D/DRC Case

1634 Main Street

DESIGN/DEVELOPMENT REVIEW COMMISSION
DESIGN REVIEW DISTRICT
HISTORIC AGENDA
EVALUATION SHEET
Case # 1

NATURE OF REQUEST: Request Certificate of Design Approval for exterior changes and Preliminary Certification for the Bailey Bill

Above: 1937 image from *The State*

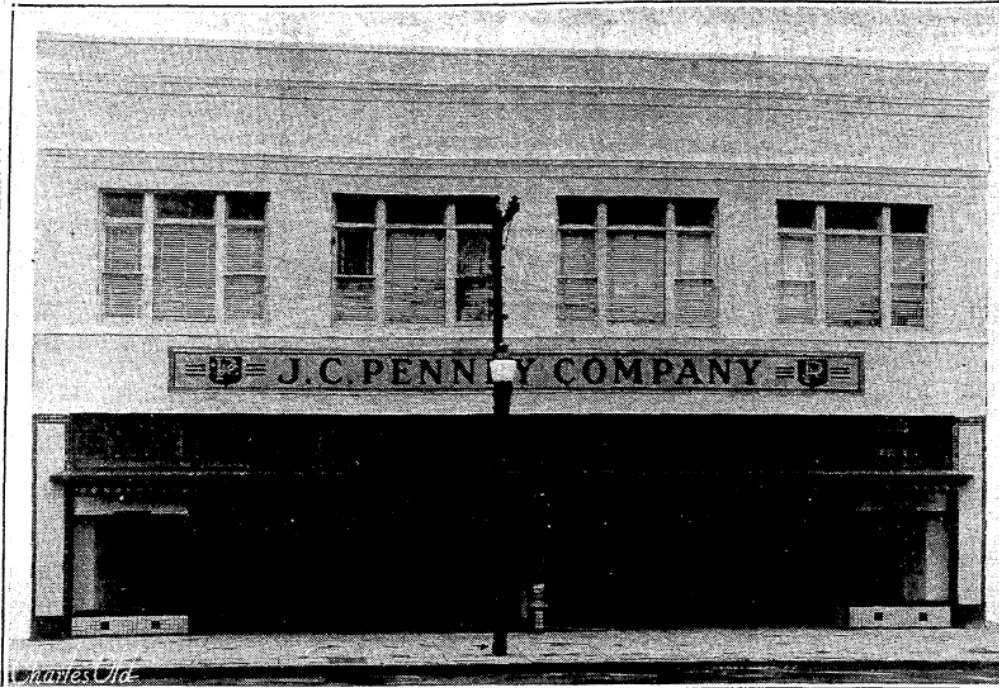
The current proposal is to restore the second floor of the façade to its 1937/1940s era façade and correct the expanded window openings and install historically appropriate windows. The first floor would return to the 1940s era appearance. While this is not the “original” appearance of the 1930s remodel by J.C. Penney, it is one of their attempts to continue to modernize and attract customers and is part of the building’s period of significance within Main Street’s heyday.

The façade's recreation will replicate a historic storefront that was on this building and will not add conjectural features from other buildings.

EXTERIOR ELEVATIONS

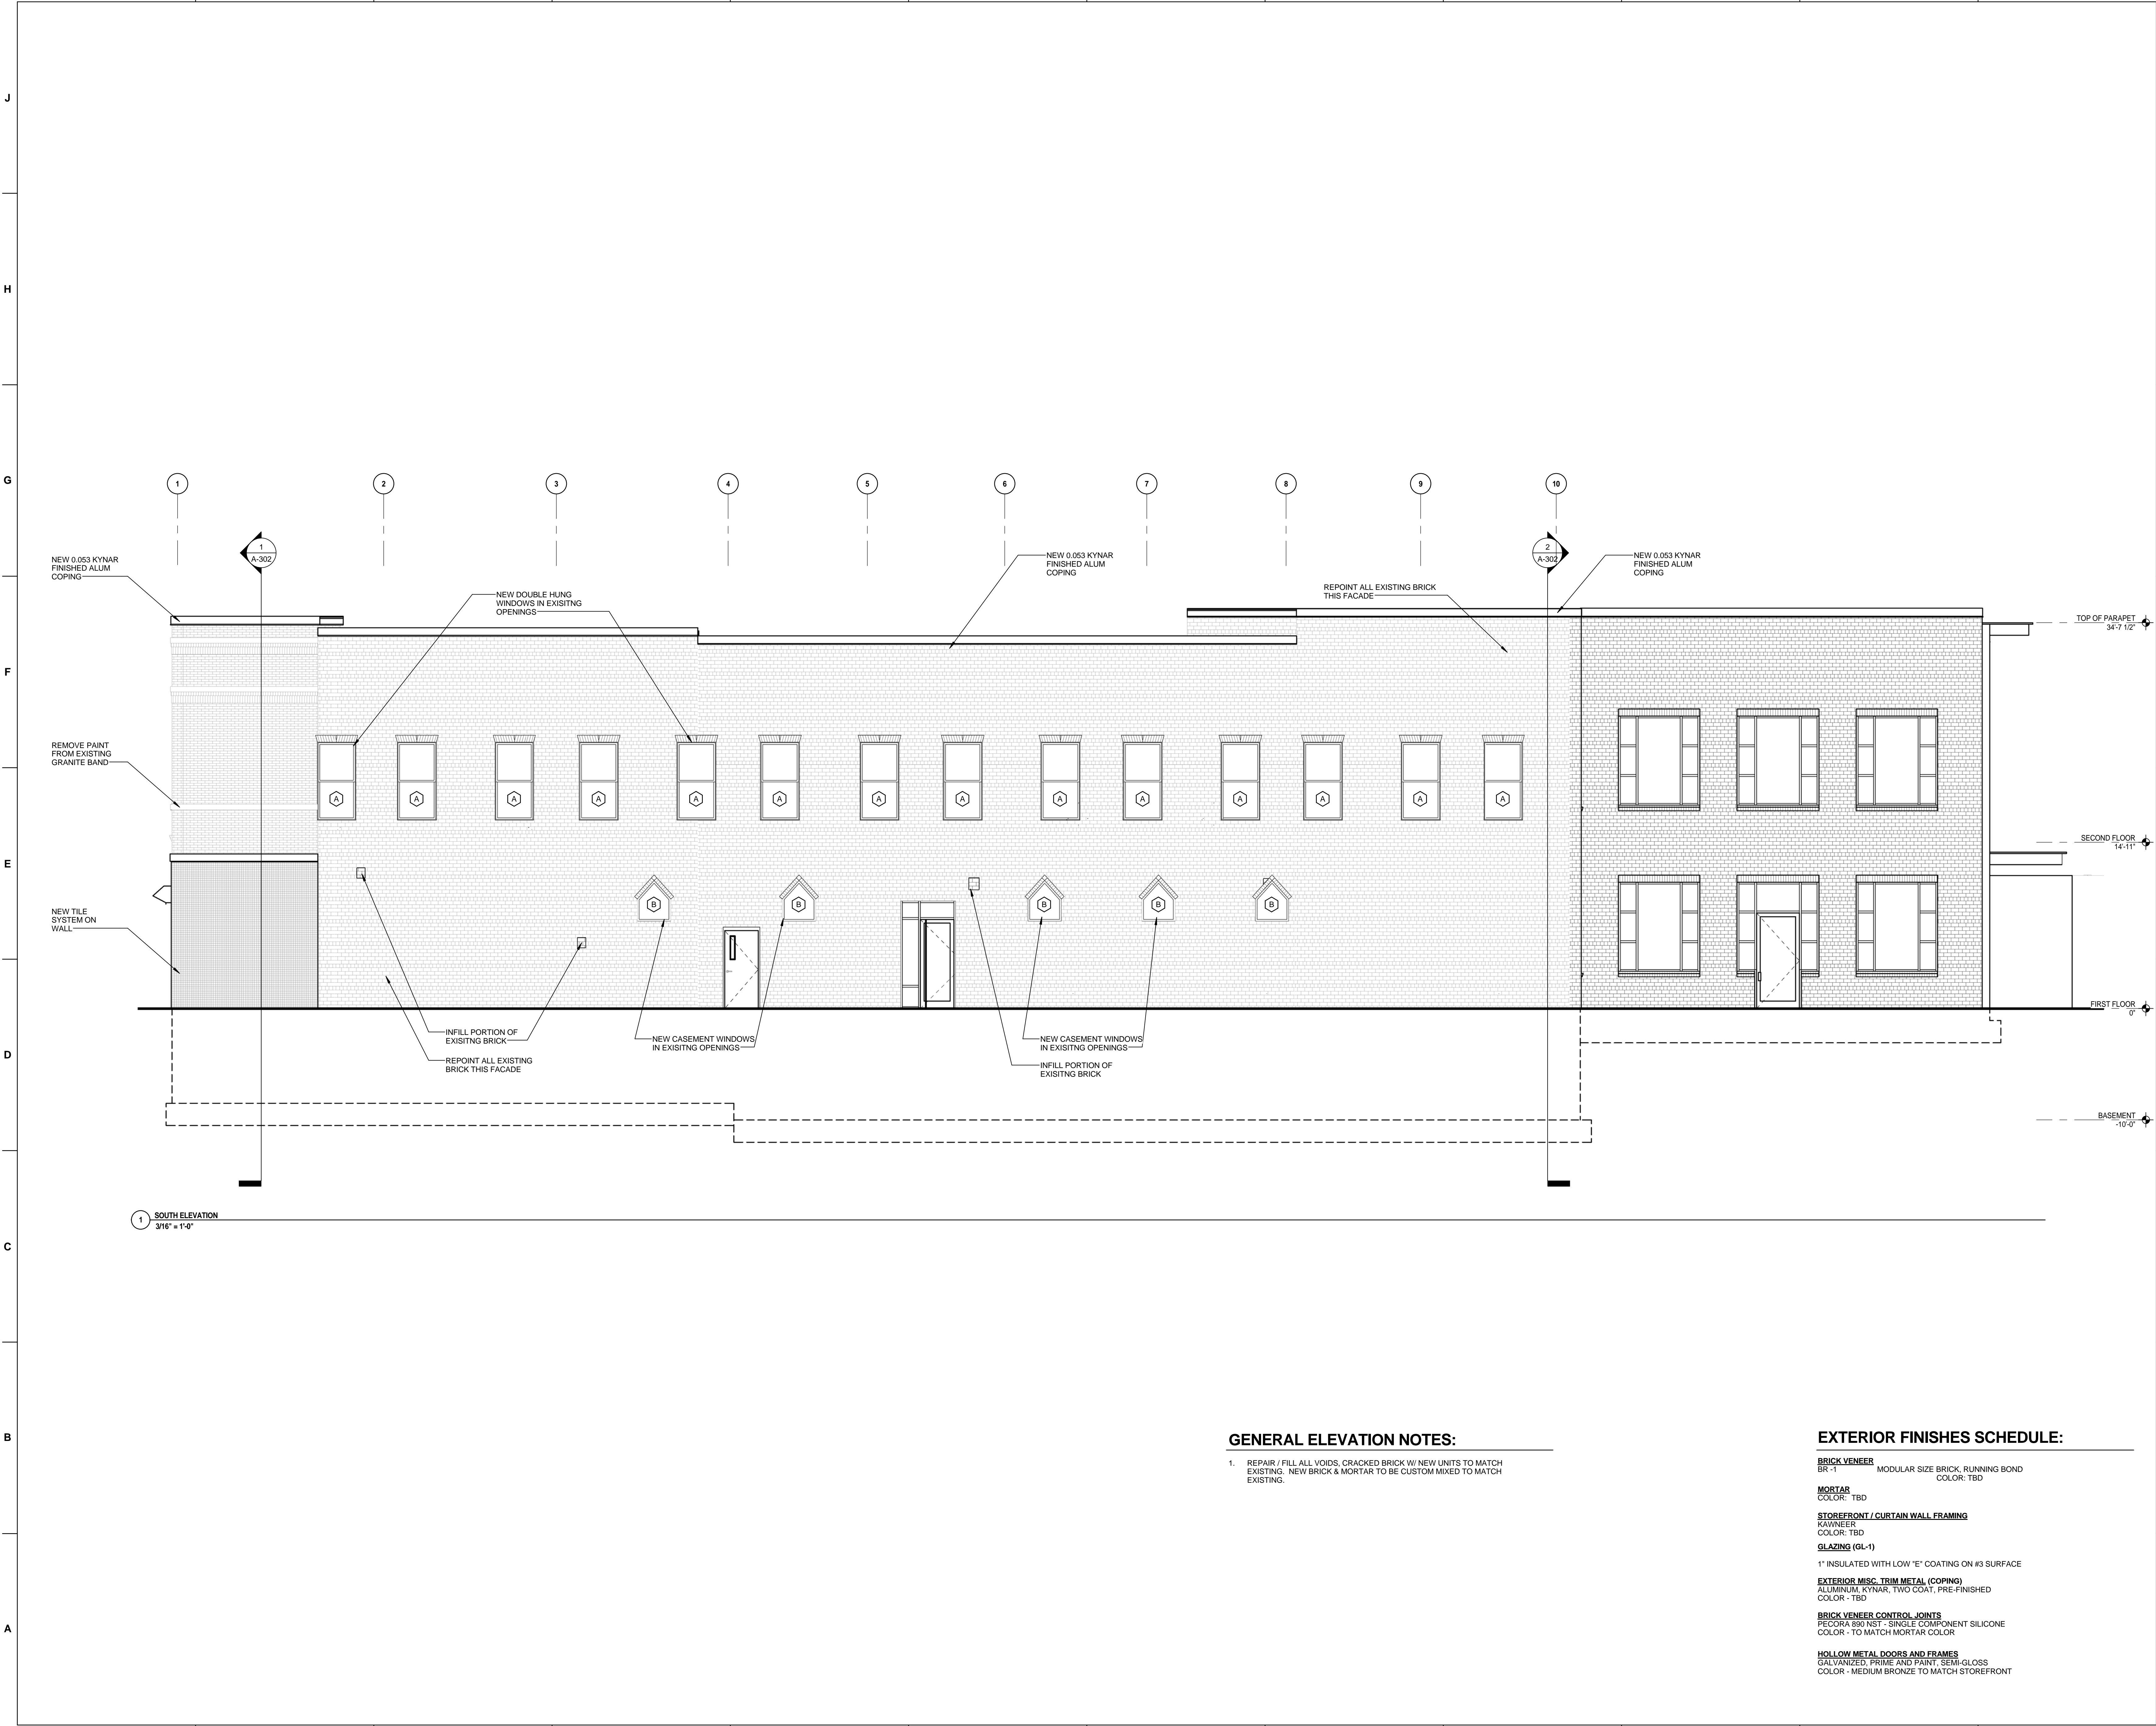
The submitted drawings do not reflect the latest conversations with the applicants and are not highly detailed regarding windows and the storefront due to ongoing review by the State Historic Preservation Office. Recent meetings with them by the applicant have resulted in the decision to use aluminum-clad wood windows. Other changes to the drawings include the removal of the proposed stair/elevator tower addition on the rear; subsequently a new rear elevation will be

submitted at a later date. The submitted drawings are also not correct in their note to remove the iron star vents visible above the second floor windows along the south elevation.

The upper story of the façade has had its window openings elongated. These will be returned to a correct height by infilling the sill areas with matching brick. Other broken or missing cast stone details on the façade's upper floor will be repaired or replaced in kind.

Staff recommends a Certificate of Design Approval for the project as proposed based on its conformance with Sec. 17-674(d) of the City Ordinance with the following conditions:

- the storefront and rear wall details be submitted for review by staff and that staff may return this project to DDRC for further review if necessary when those details are available
- all details deferred to staff.
